Pinehaven Structural Works - Technical Review - Flooding

Peer Review

Prepared for Greater Wellington Regional Council
Prepared by Beca Limited

21 November 2019

Figure 4-3 Hydrological catchments

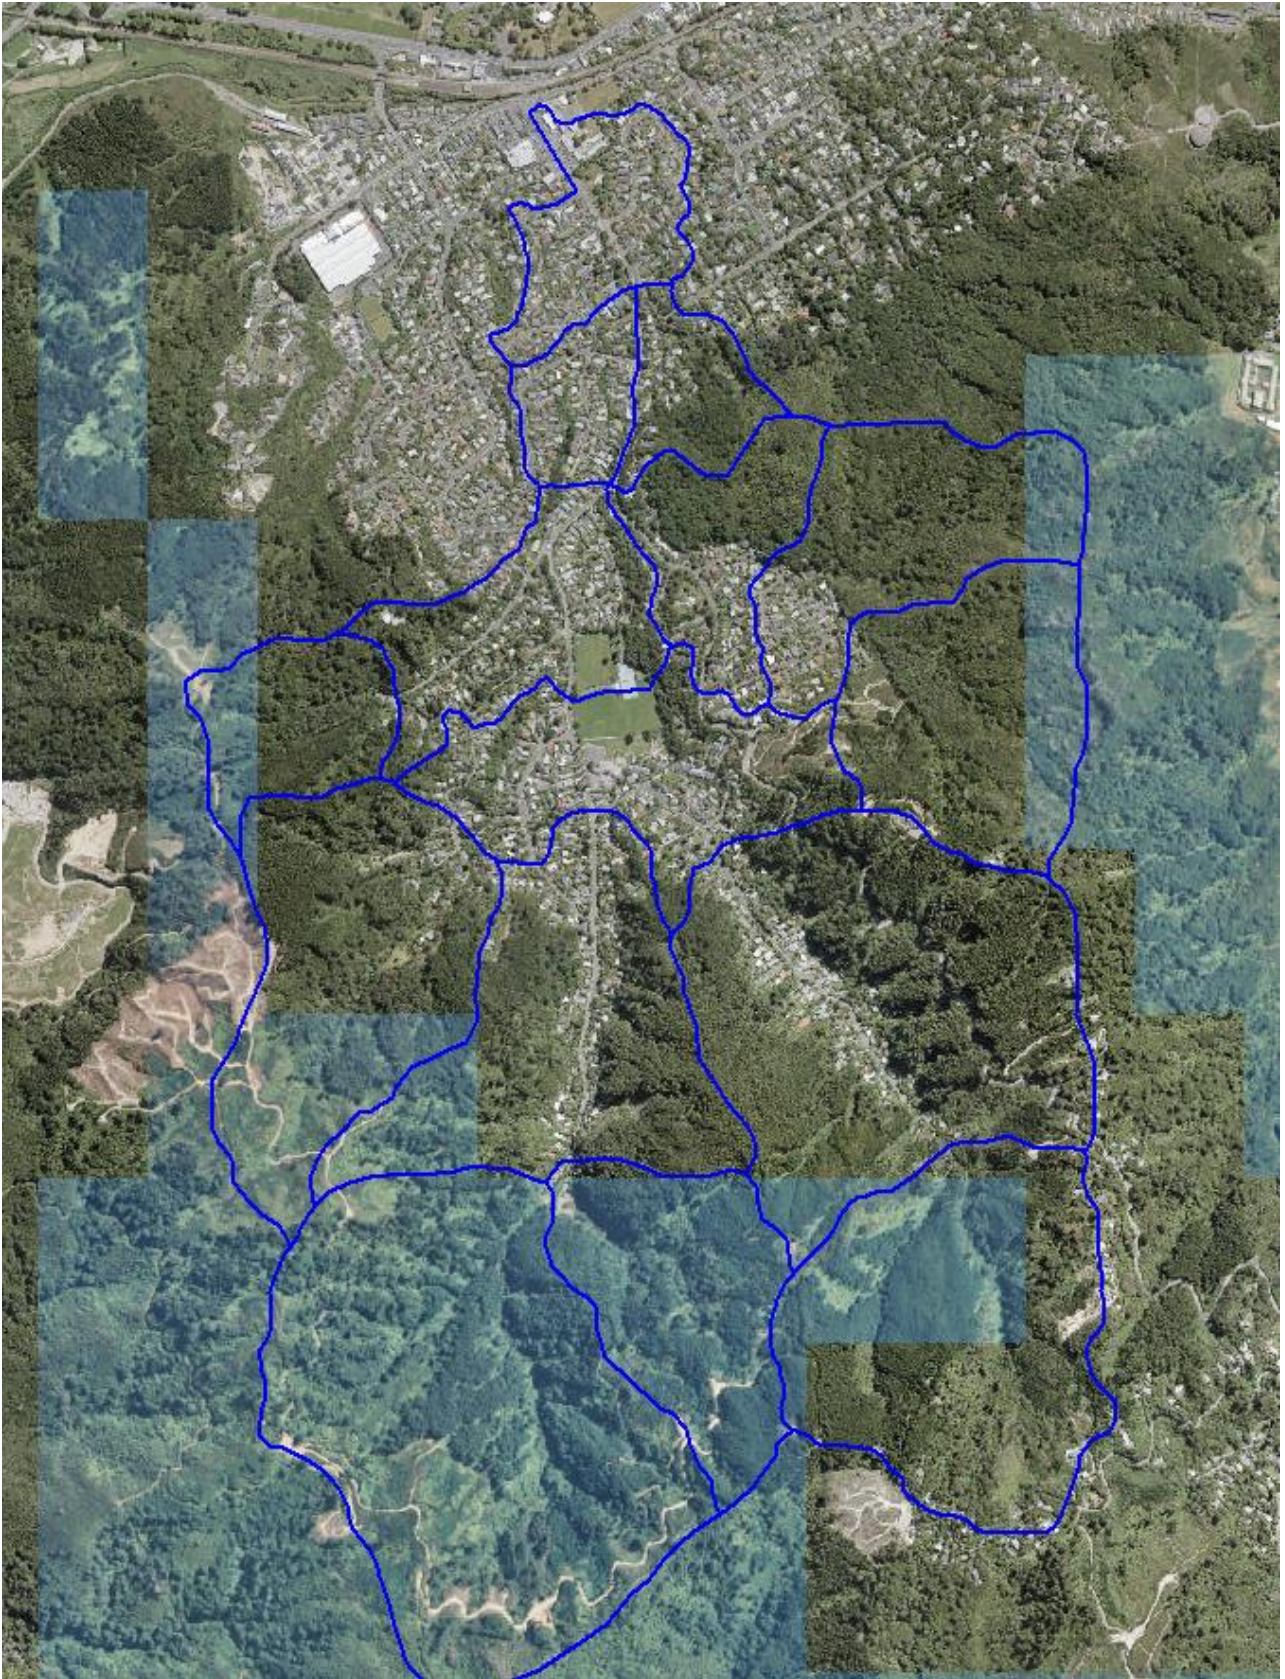
<p>Catchments</p>	<p>Figure 4-3 shows the catchments used in the hydrological modelling. The catchments range from 0.735km² to 0.1397km². Catchments of this size are large for a detailed design model, but given the lack of detail in the hydraulic model (e.g. no stormwater pipe network) these are appropriate. Based on the 2D surface supplied with the model they appear to be delineated appropriately.</p>	<p>Findings and comments on catchment size acknowledged. Agreement with appropriateness of catchment size and delineation, based on resolution and detail of base model.</p>	<p>CLOSED</p>	<p>1</p>	<p>Yes</p>

Figure 4-4 Changes to DEM – Design model on the left and Base model on the right

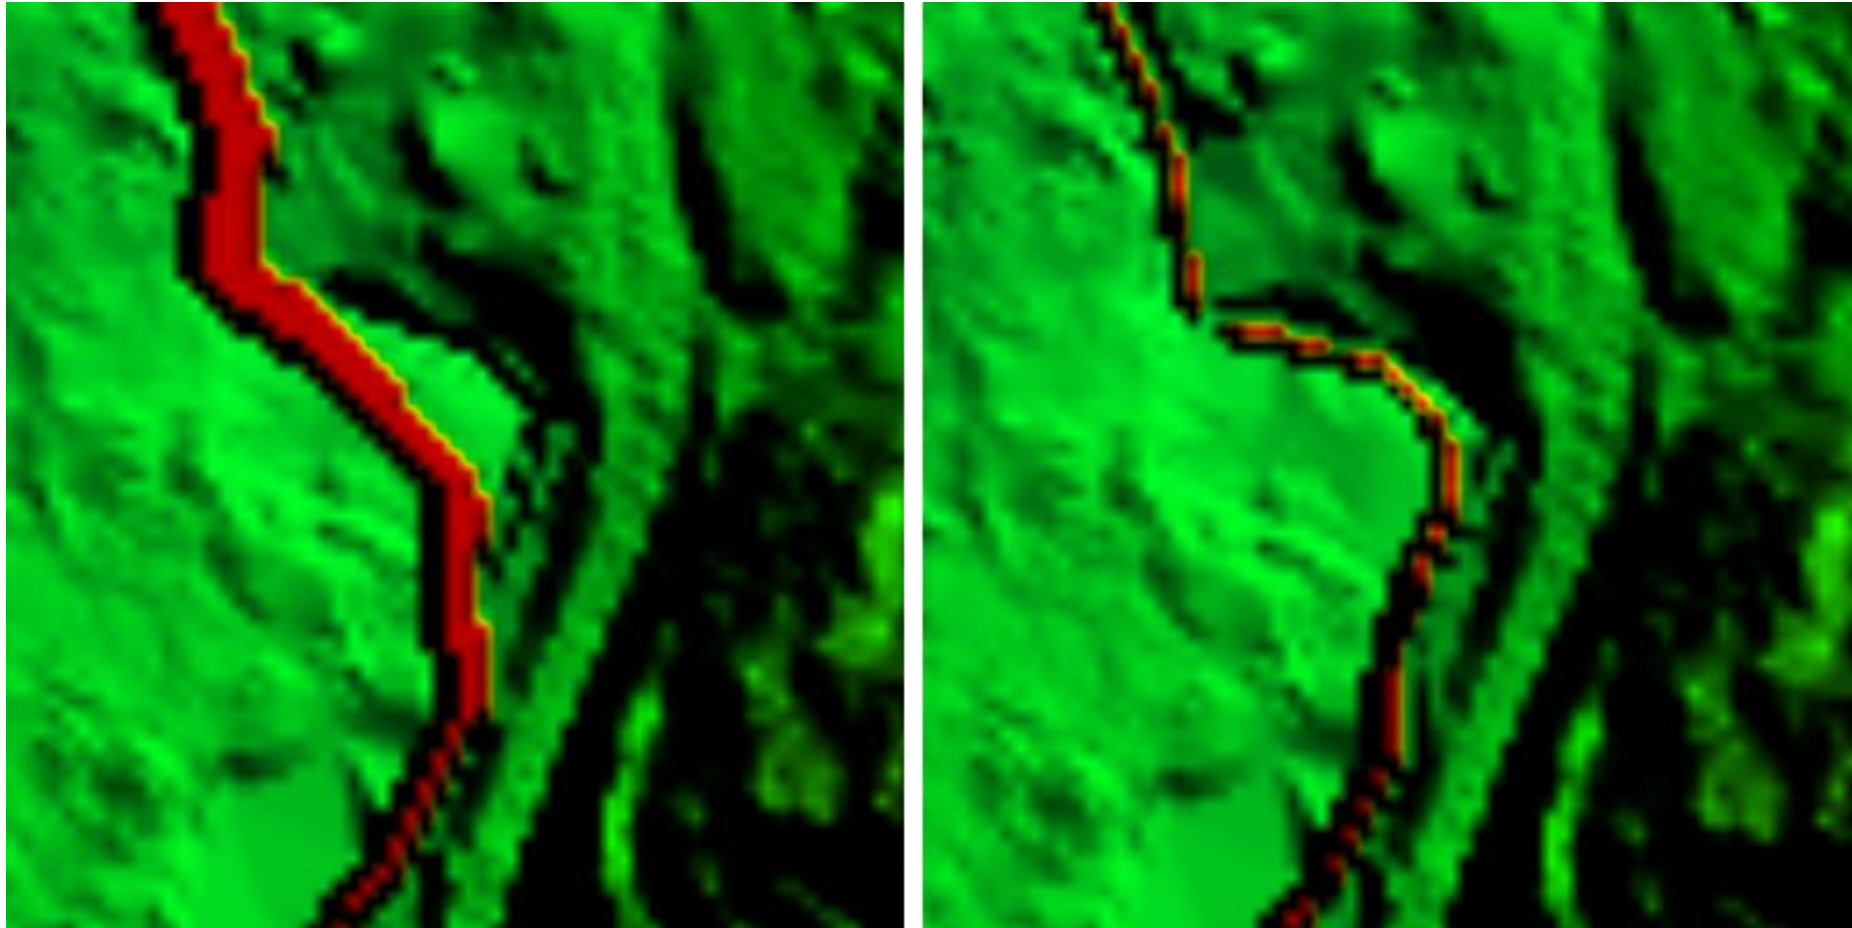
Item Checked	Findings & Comments	Modeller's response	Reviewer close out comments	Rating	Fit for use
MIKE21					
Grid/Mesh	<ul style="list-style-type: none"> Model includes two gridded surfaces; representing Base (pre) and Design (post) proposed stream works Model updated with 2013 LiDAR The model uses a grid of 2x2 m. This is an appropriate level of detail, and more refined than the 5x5 m grid reviewed in 2015. The extent of the grid is such that the flood plain is covered. This is confirmed by the 100-year ARI results showing that that no water is glass-walling at the edges of the grid. The Pinehaven Stream between Pinehaven Reserve and Whitemans Rd has been blocked out of the grid where M11 is present to prevent double counting. The blocking out has been increased in areas of stream widening (this matches changes to the M11 cross-sections) as indicated by the red areas in Figure 4-4. The stream centreline and mesh blockout at 28 Blue Mountains Rd between the Design model and Base model is slightly different. 	Agreement with findings and comments noted.	CLOSED	0	Yes

Figure 4-6 Cross-section 1496

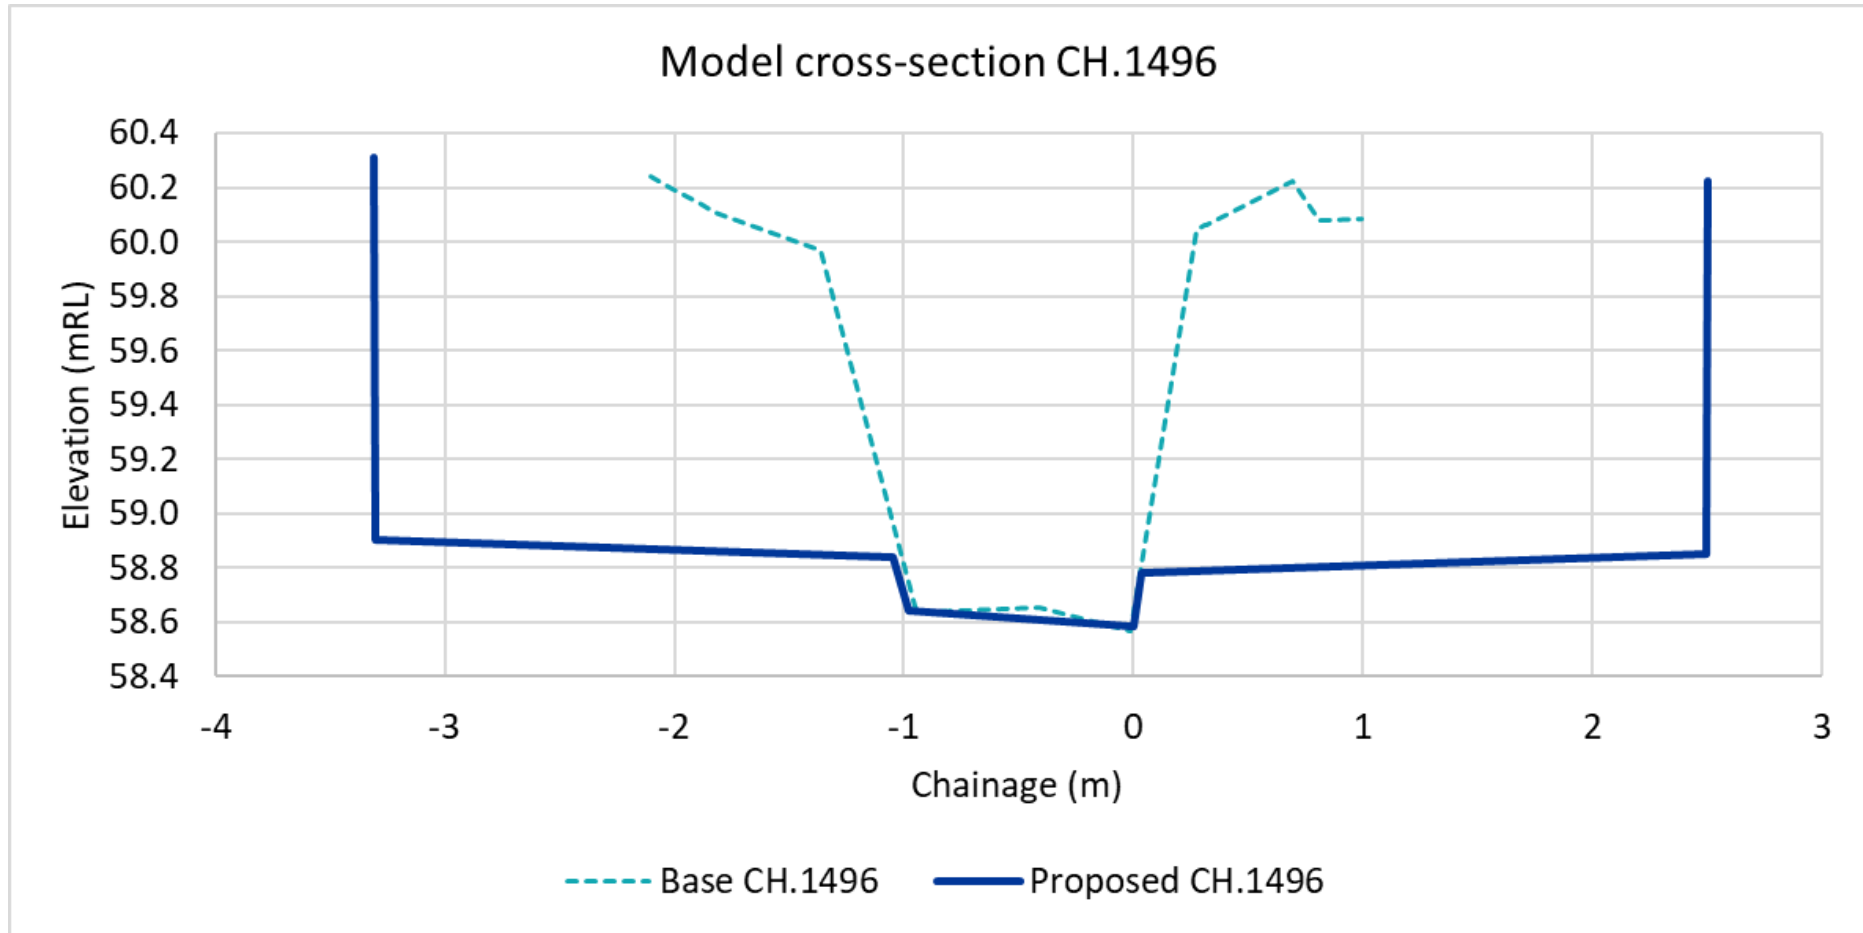
Item Checked	Findings & Comments	Modeller's response	Reviewer close out comments	Rating	Fit for use
Cross-sections	<ul style="list-style-type: none"> Design drawings of the proposed cross-section have not been received and therefore we cannot comment on the representation of these in the model. We are limited to comparing the design cross sections to those in the Base case model. The stream works detailed in the <i>Pinehaven Stream Improvements</i> report appear in model chainages Ch 1488 – 1604 inclusive; and Ch 1838 – 2430 inclusive (2017 12d design). An example is shown in Figure 4-6 for cross-section 1496. The lower ~200mm of channel has been left the same as the Base model representing no modification to this portion of the cross-section The design cross-sections contain vertical walls (approx 1.5m high). <u>Note that if these can't be achieved due to stability etc any changes to the side slopes would need to be re-modelled as it may result in a loss in conveyance.</u> 	<p>Additional survey was collected to update the quantity and resolution of stream cross-sections from what was represented in the preliminary models.</p> <p>Proposed cross-sections included reference to updated survey information where applicable.</p> <p>In vertical cross sections, up to a 2-inch per row of blocks may be integrated into the proposed design.</p> <p>Following completion of final design of the block walls, if a batter is proposed, a check will be performed on all cross sections to confirm that the effective flow area is not decreased (it is noted this may extend top of bank extents by a nominal amount).</p>	<p>We agree with the modeller's response. Checks should be made to the final design cross-sections to confirm that the hydraulic performance meets the performance of the reviewed model.</p> <p>CLOSED</p>	1	Yes

Figure 4-7 Cross-section 1854

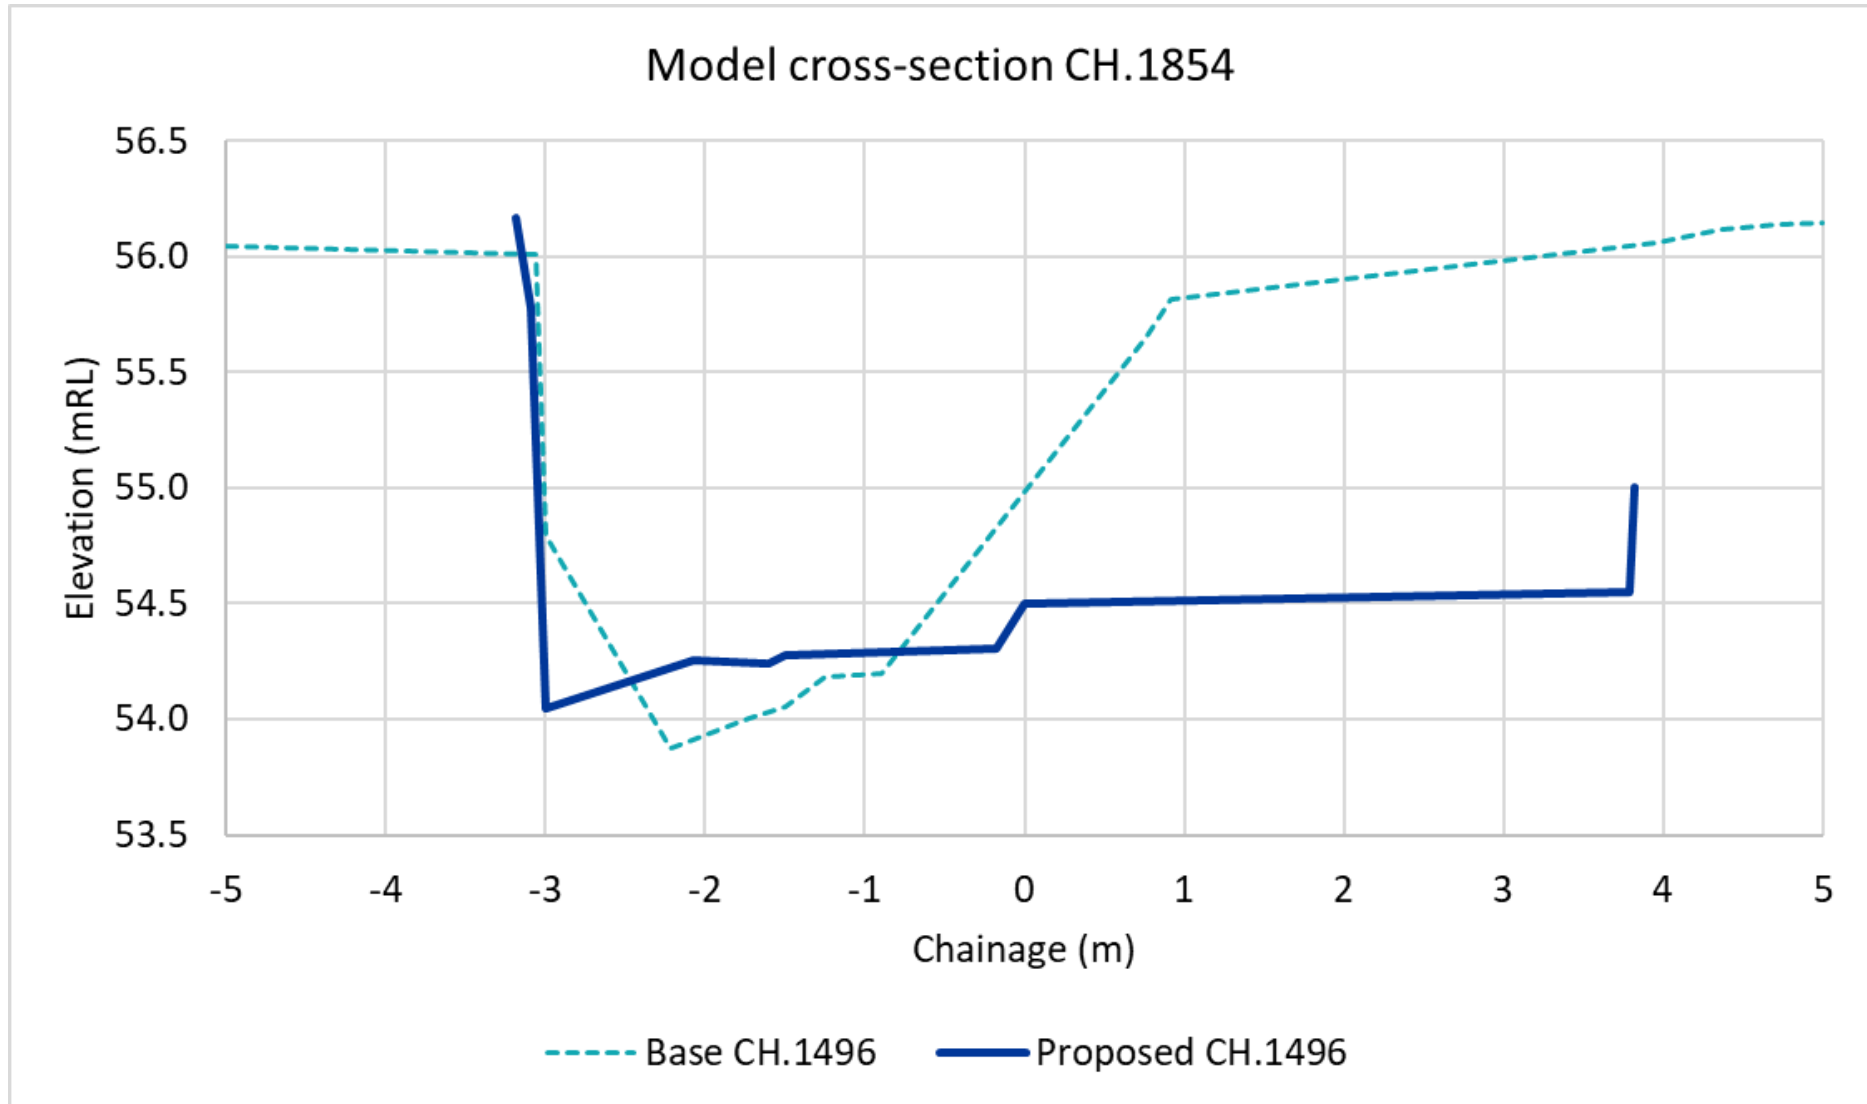
Item Checked	Findings & Comments	Modeller's response	Reviewer close out comments	Rating	Fit for use
Roughness	<ul style="list-style-type: none"> The edges of some design cross-sections have had roughness increased to represent walls, though the material is not stated. Ch1838-1847 has High/low roughness zones, whereas CH.1854-1883 does not. Without a set of drawings/design can't comment if these are appropriate. 0.035n Global roughness in both models Fresh plains (extensions of the channel below the bank level to accommodate 'fresh flows') / planted benches appear to have been created in some of the design cross-sections, including cross-section 1854 (Figure 4-7). If they are to be planted, then no account has been taken of the change in model roughness. Modeller to confirm whether changes in roughness have been, or need to be, made. 	<p>Comments acknowledged.</p> <p>Where roughness was used to represent existing private bridges, walls or other structures in the model, appropriateness of the roughness factors were confirmed with Wellington Water.</p> <p>It is expected that the final planting plan and recommended maintenance practices will be consistent with roughness factors used in the model in 'fresh plains' areas below the proposed top of bank and that changes to roughness represented in the model will not be required.</p> <p>The roughness values used were reviewed internally and with our client to confirm they are appropriate.</p>	<p>The channel roughness factor used are appropriate for the stage of design.</p> <p>The modeller should confirm that the appropriate roughness is used when the "final planting plan and recommended maintenance practices" are confirmed.</p> <p style="text-align: center;">CLOSED</p>	2	Yes
